Illinois Tollway Base Sheet Revisions			
Section M	Base Sheet Drawings		
	Drawing	Modification Summary	Effective: 03-31-2016
	All	The electronic (pdf) version of the Standard Drawing are now made searchable (text).	
Erosion Sediment Control (ESC)-Series 200			
M-ESC-205	Sediment Basin Dewatering Device		
	Revised Note 7, removed proprietary name from skimmer device.		
Roadway (RDY)-Series 400			
M-RDY-408	Approach Slab, Mainline		
All	Changed Transverse Reinforcement size and spacing in the bottom mat of the bridge approach slab and transition approach shoulder slabs from #6@9" to #8@4" to be in conformance with IDOT ABD Memo 15.8.		
All	Changed Transverse Reinforcement size and spacing in the top mat of the bridge approach slab and transition approach shoulder slabs from #5@12" to #5@6" to be in conformance with IDOT ABD Memo 15.8.		
All	Changed Longitudinal Reinforcement size and spacing in the top mat of the bridge approach slab and transition approach shoulder slabs from #4@15" to #5@6" to be in conformance with IDOT ABD Memo 15.8.

Tollway Base Sheet Revisions		
Section M	Base Sheet Drawings	
	Drawing	Modification Summary Effective: 03-31-2016
	Maintenance of Traffic (MOT)-Ser

M-ITS-1000

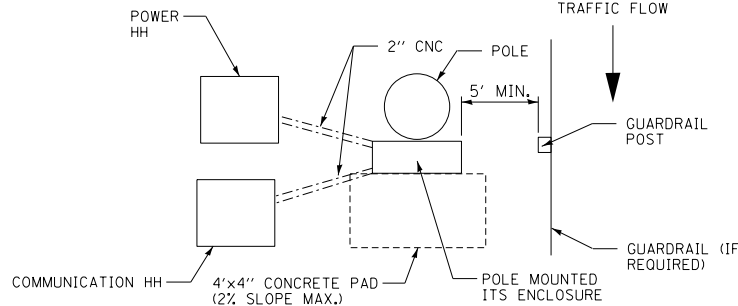
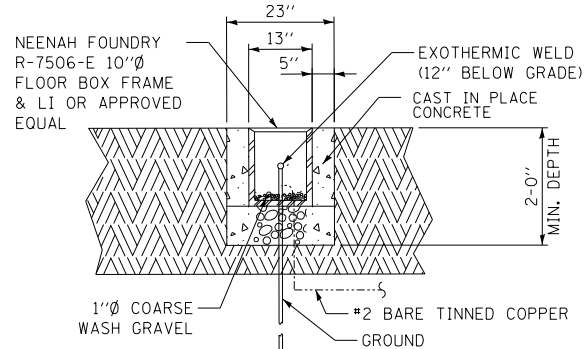
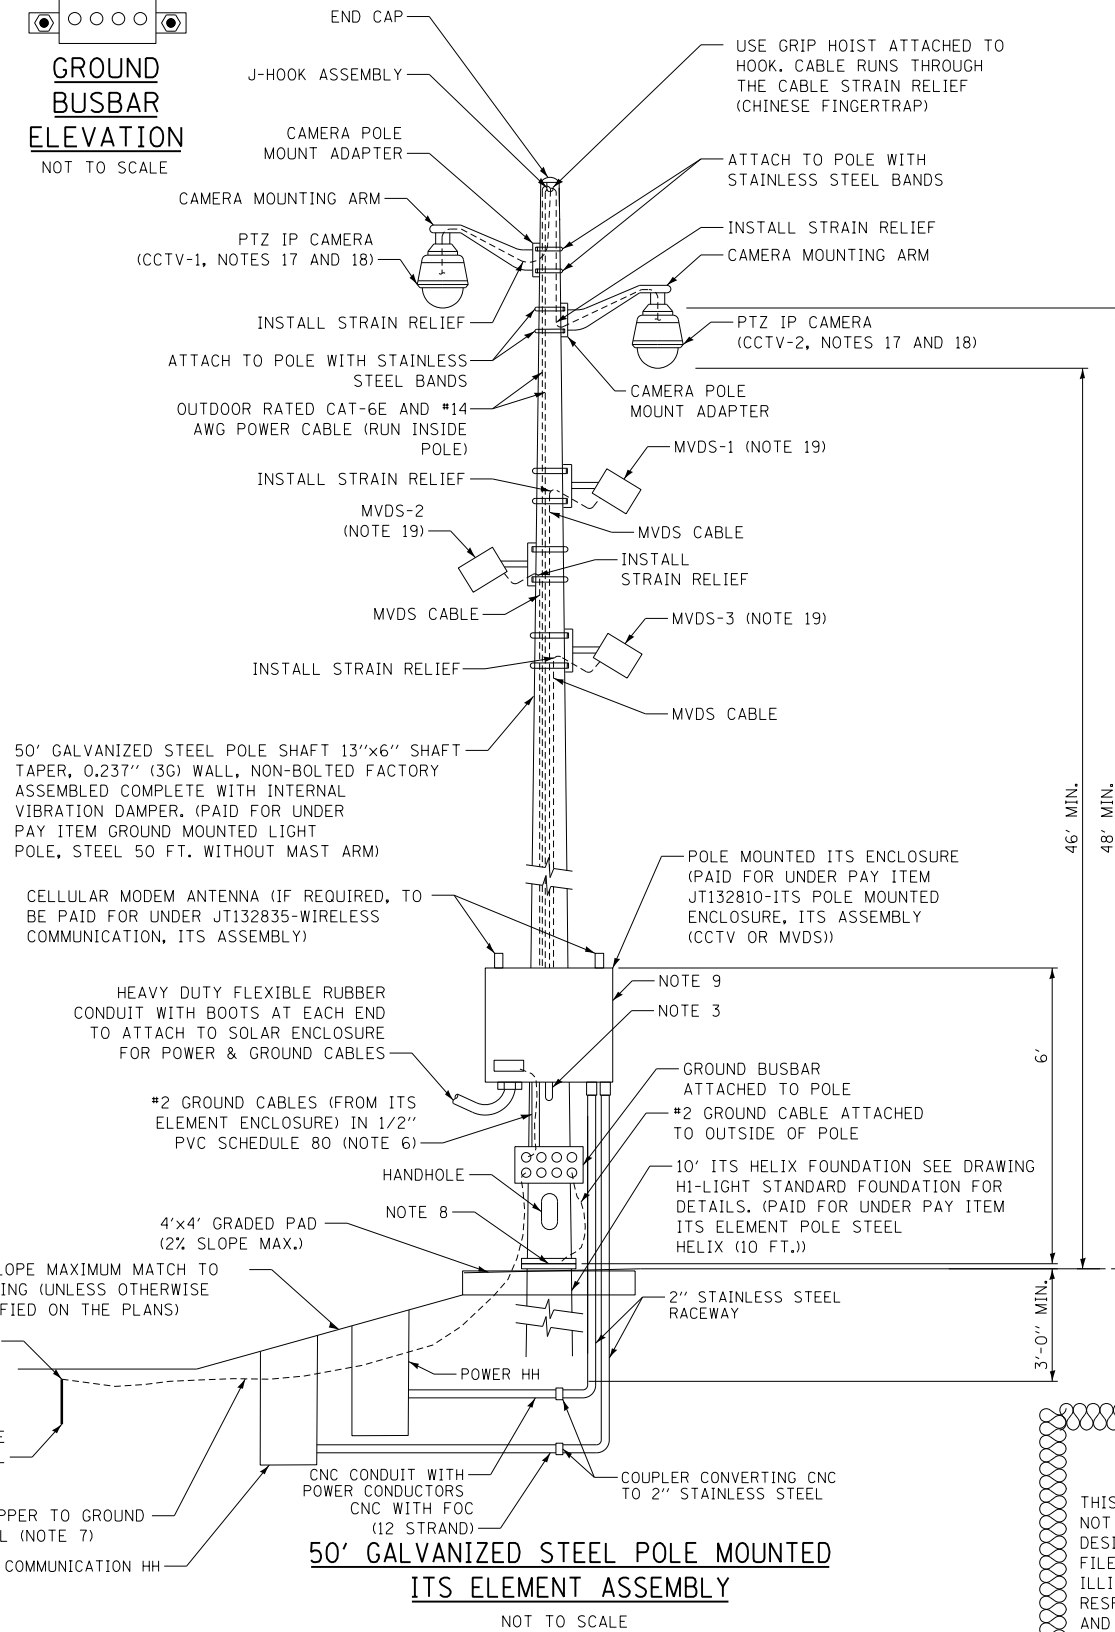
Sheet 7	Removed Protective Coat quantity since not required to be applied to shoulder foundation.
	Sheet 8	Added note 5 to clarify limits of protective coat and revised protective coat quantity in Median Foundation Schedule.
	Pole Assembly-Series 1000	
	M-ITS-1000	ELEVATION VIEWS POLE MOUNTED ITS ELEMENT ASSEMBLY
		Added 30A-2P NEMA 4X DISC MTD ON SUPPORT DETAIL.
	M-ITS-1001	GENERAL NOTES POLE MOUNTED ITS ELEMENT ASSEMBLY
		Added Note 16 regarding disconnect switch usage.
	M-ITS-1002	ITS STANDARD FOUNDATION: New Sheet
	Dynamic Message Sign (ITS) - Series 1100	
	M-ITS-1100	Revised conduit call-outs
	M-ITS-1103	Revised 30A-2P NEMA 4X DISC MTD ON SUPPORT DETAIL. Removed pad mounted transformer.
	M-ITS-1104	Revised 30A-2P NEMA 4X DISC MTD ON SUPPORT DETAIL. Revised Note 2 to eliminate 120/208V and pad mount.
	Cabinet Wiring-Series 1200	
	M-ITS-1200	Cabinet Wiring
	All	Added HOT3, NB, and GB to Duplex Receptacle.
